Addendum No. 03

Subject: Gen. Phillip Kearny: Contract Nos. 2022-001G, 2022-001E

Location: Gen. Phillip Kearny: 601 Fairmount Avenue Philadelphia, PA 19123

PROJECT TITLE
**SDP Classroom
Modifications Kearny**

**1 LIGHTING CONTROL DETAIL
TYPICAL CLASSROOM**

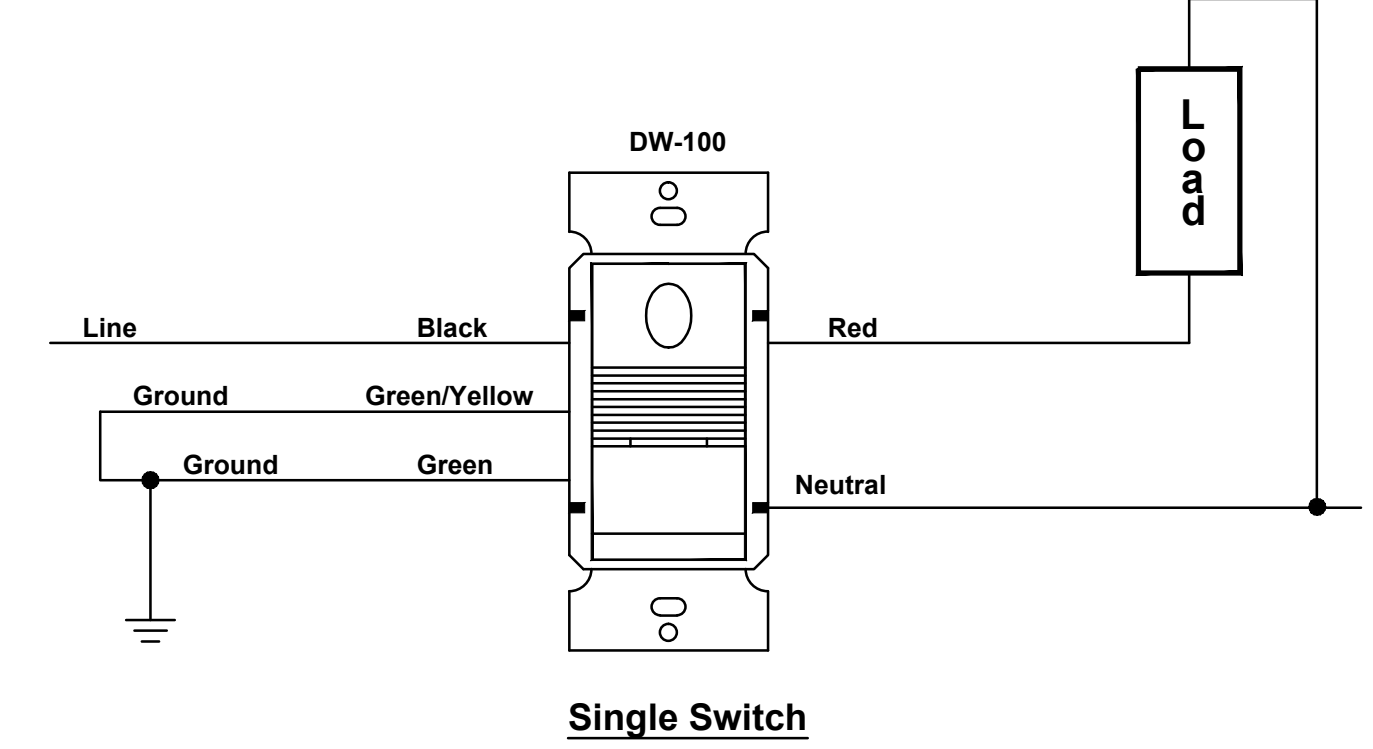
Q4: Drawing E3.01 detail #1 shows a 3-button wall switch Wattstopper #LMSW-103. Please confirm this is the symbol  shown on the floor plans. Please confirm the design intent is to program this LMSW-103 as a dimmer and the 3 buttons should be programmed as toggle on/off (1), dimmer raise (2), and dimmer lower (3).

A4: Confirmed. Refer to Sequence of Operation for additional info.

**4 TYPICAL LIGHTING CONTROL DETAIL
VACANCY SENSORS**

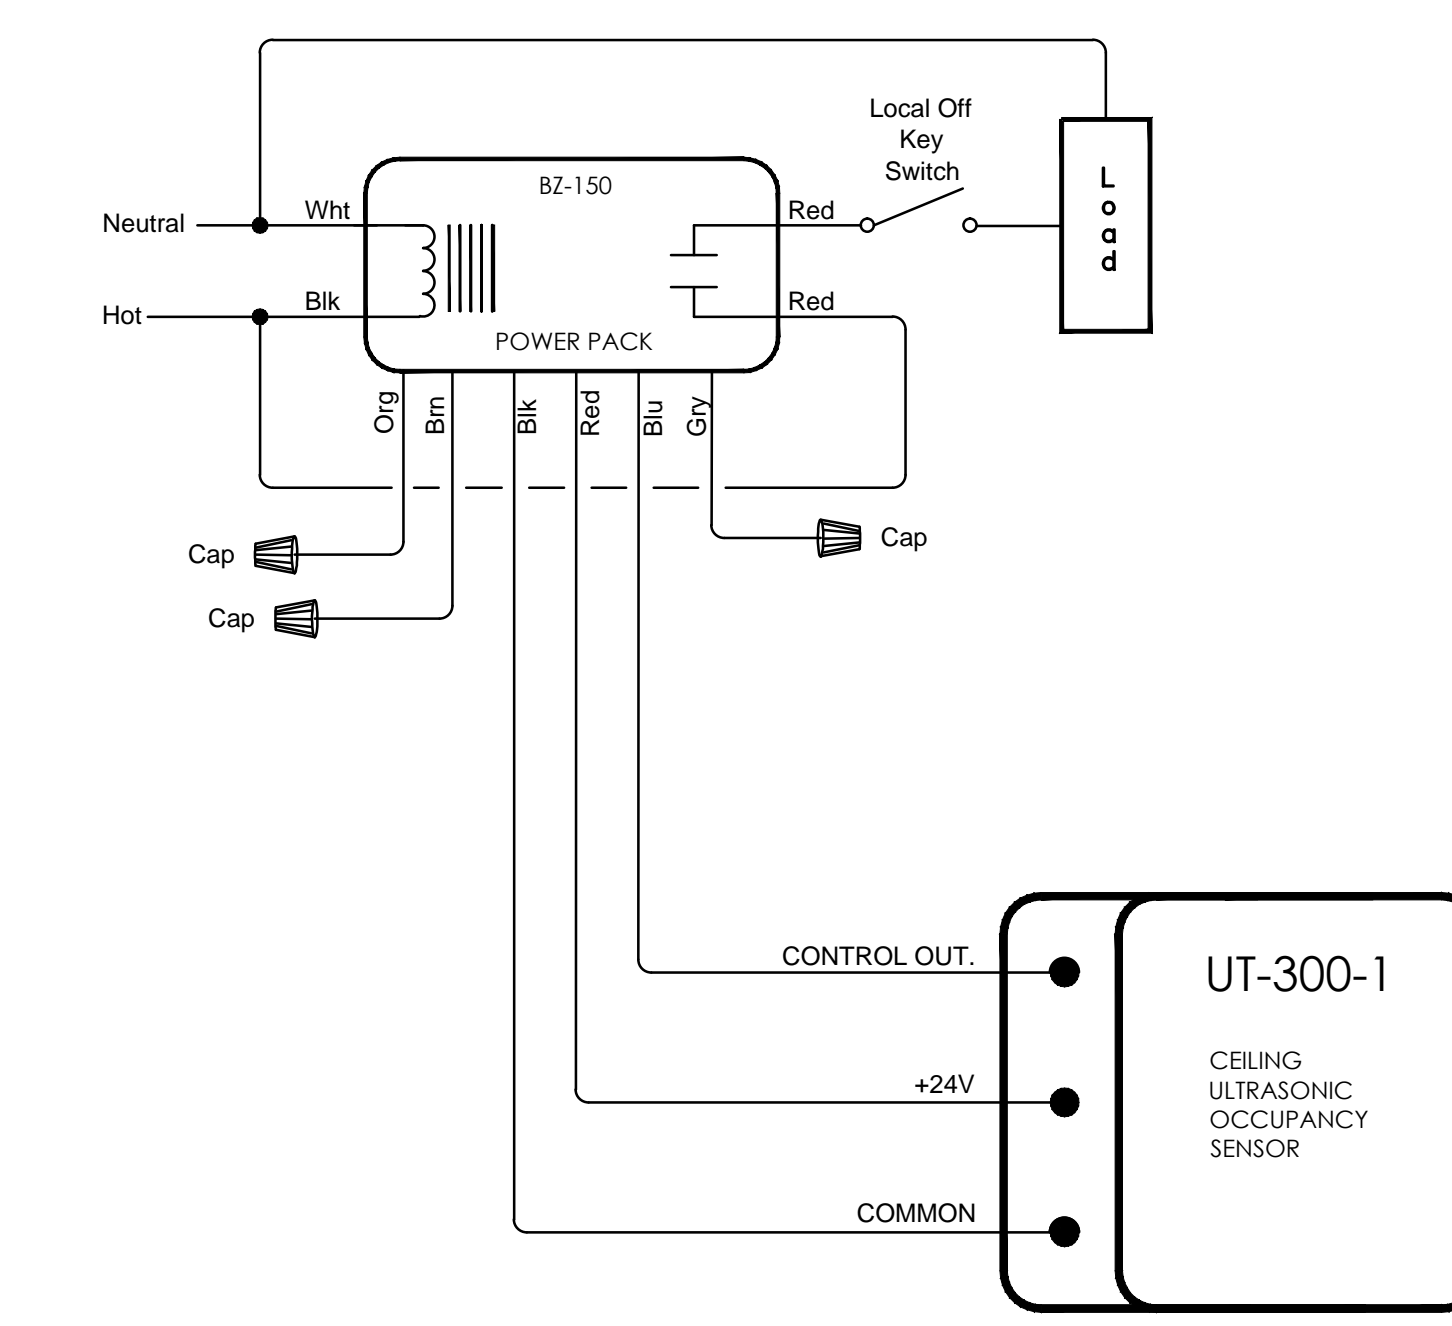
Q5: For the following zones, should these be digital controls with 1 zone switched room controller? Or should the controls be non-digital per drawing E3.01 detail #4 with momentary low voltage switches, momentary power pack, and non-digital occupancy sensor? Please provide basis of design Wattstopper part numbers for the low voltage switch, occupancy sensor, and power pack/room controller depending on the answer.

- a. Drawing E2.01
 - i. Zone "c" Classroom 107
- b. Drawing E2.02
 - i. Coats 202C
 - ii. Coats 203C

**A5: Classroom 107 - Refer to attached E3.01 for added Lighting Control detail 6/E3.01.
Coats 202C - 4/E3.01 is the applicable detail - Refer to attached E3.01 for updated detail.
Coats 203C - 4/E3.01 is the applicable detail - Refer to attached E3.01 for updated detail.**

5 SINGLE OCCUPANCY SENSOR CONTROL DETAIL

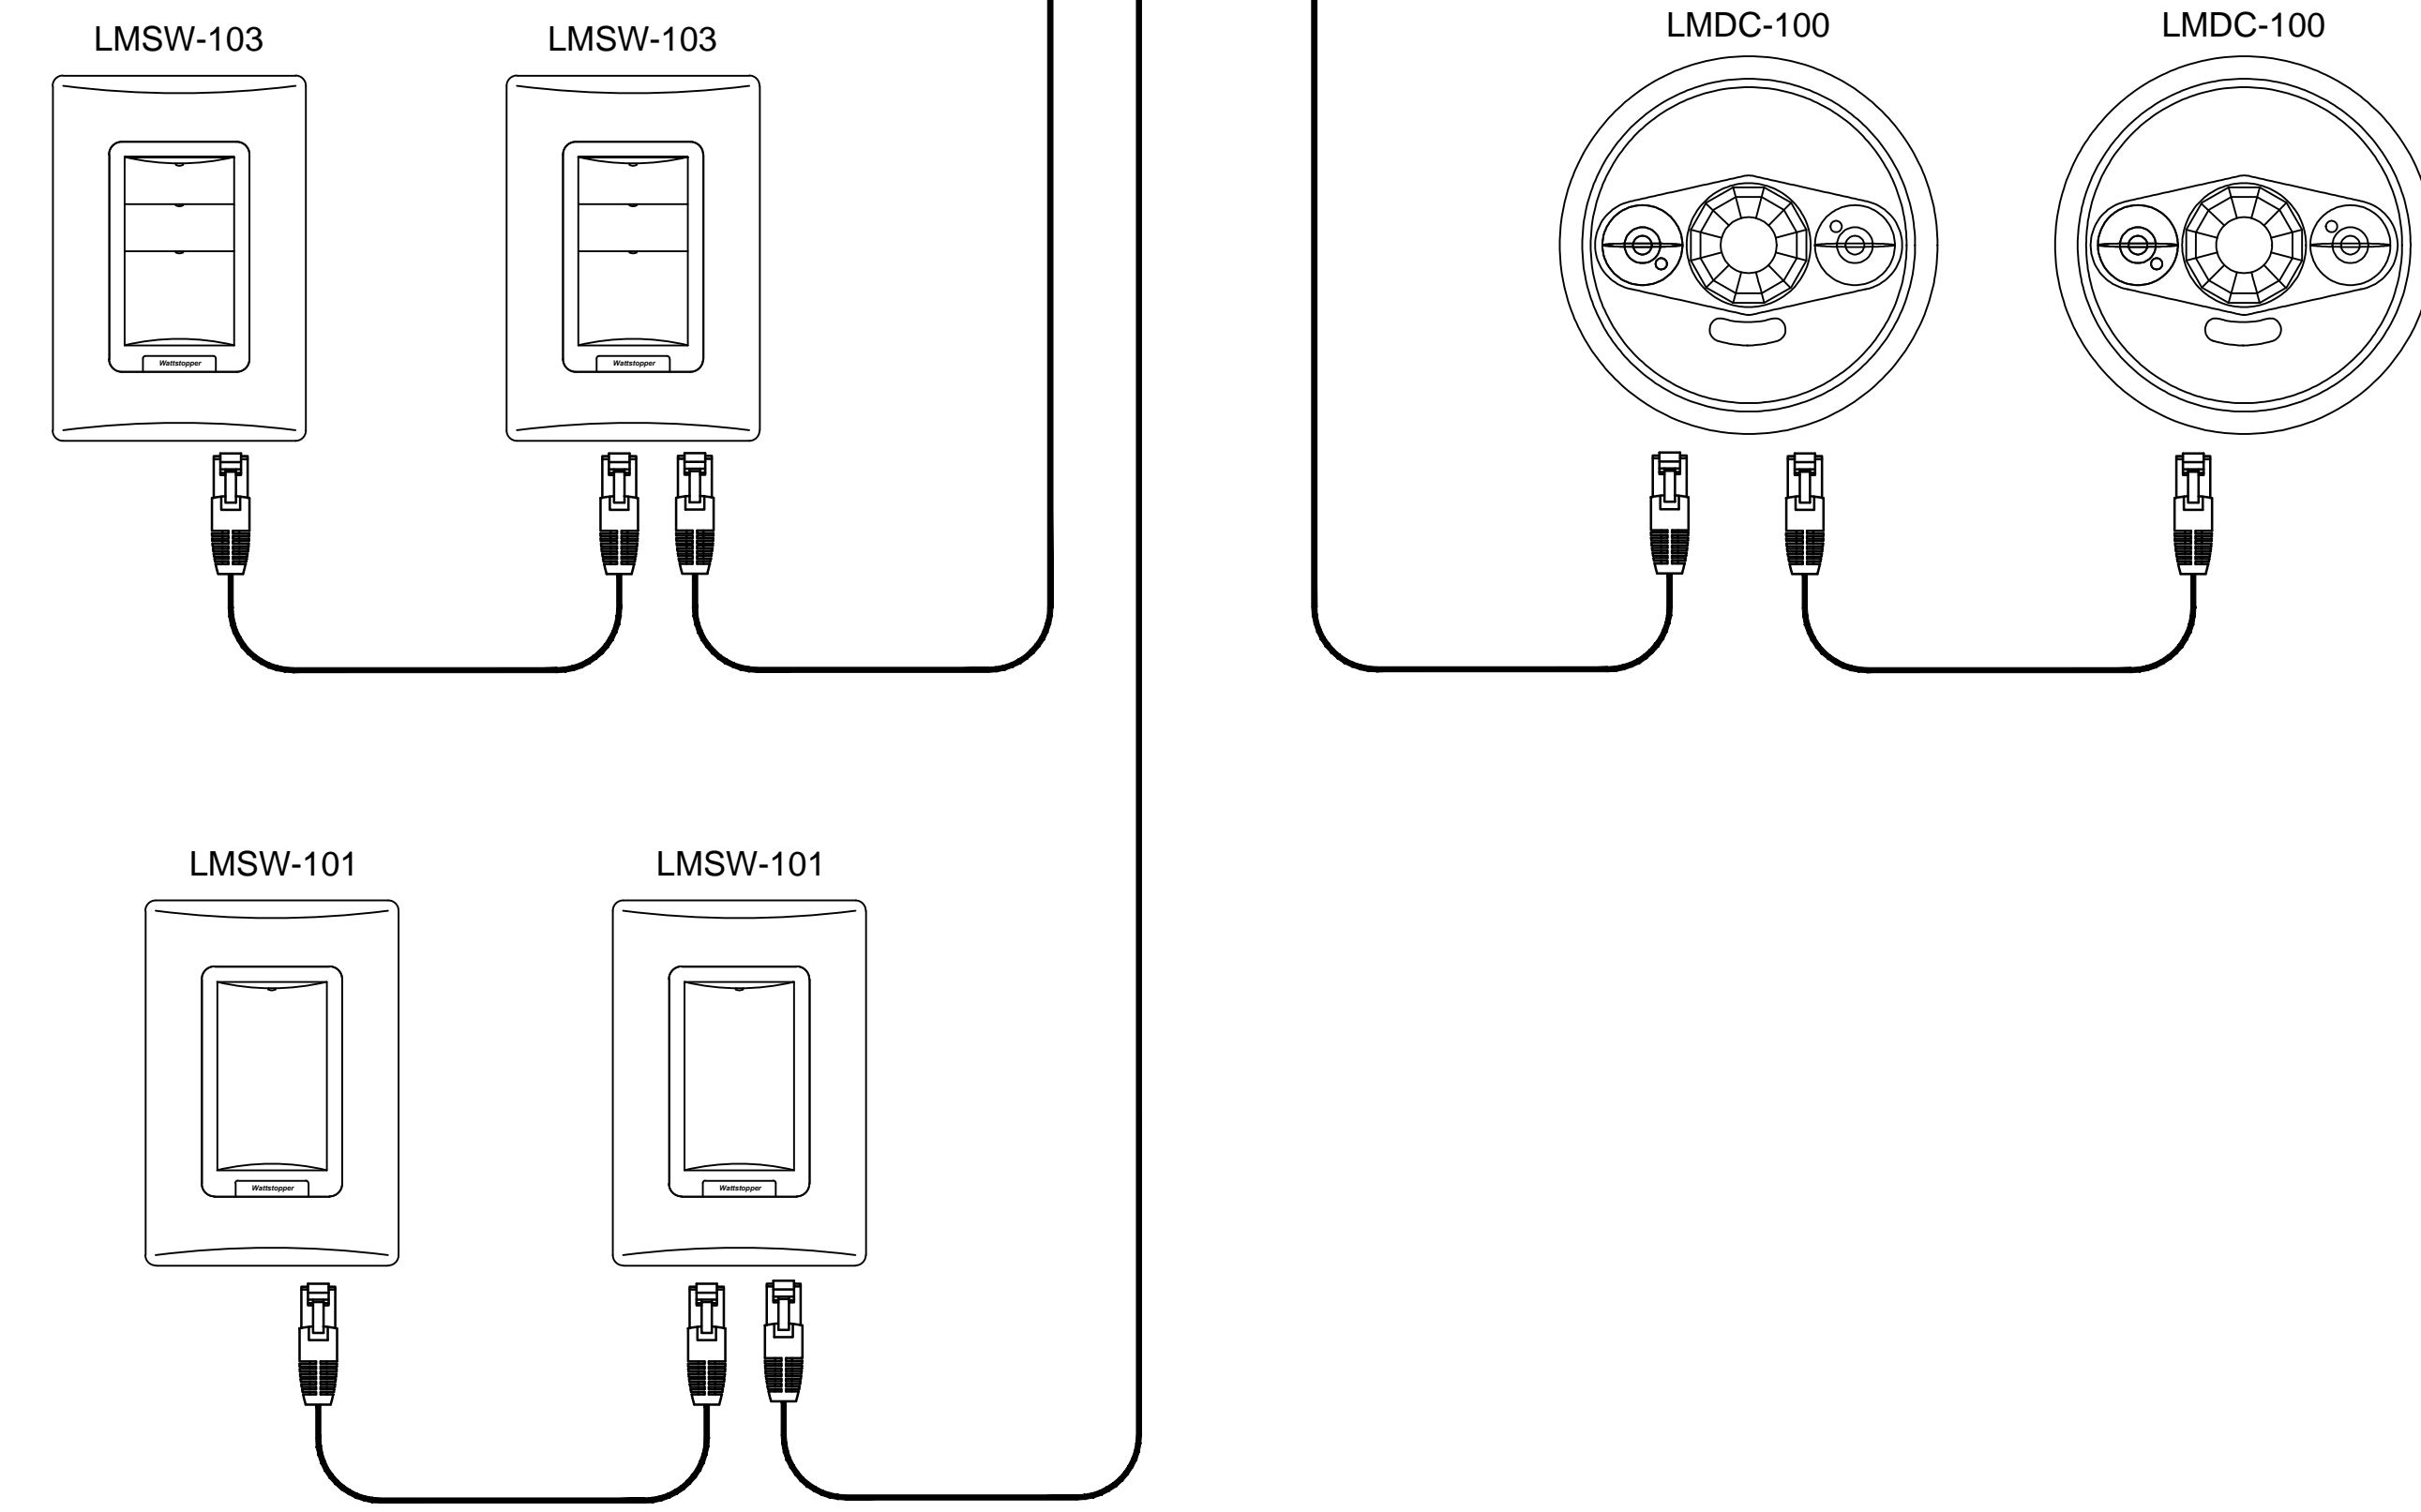
Q6: Drawing E2.01 detail #5 shows lighting control in Toilet Room 107T. This room has a line voltage keyed switch **SK**. Drawing E3.01 does not show an applicable detail for this control scenario. Please clarify design intent and basis of design Wattstopper number for the occupancy sensor and possible power pack.

A6: Refer to attached updated E3.01 drawing with added applicable detail 5/E3.01.
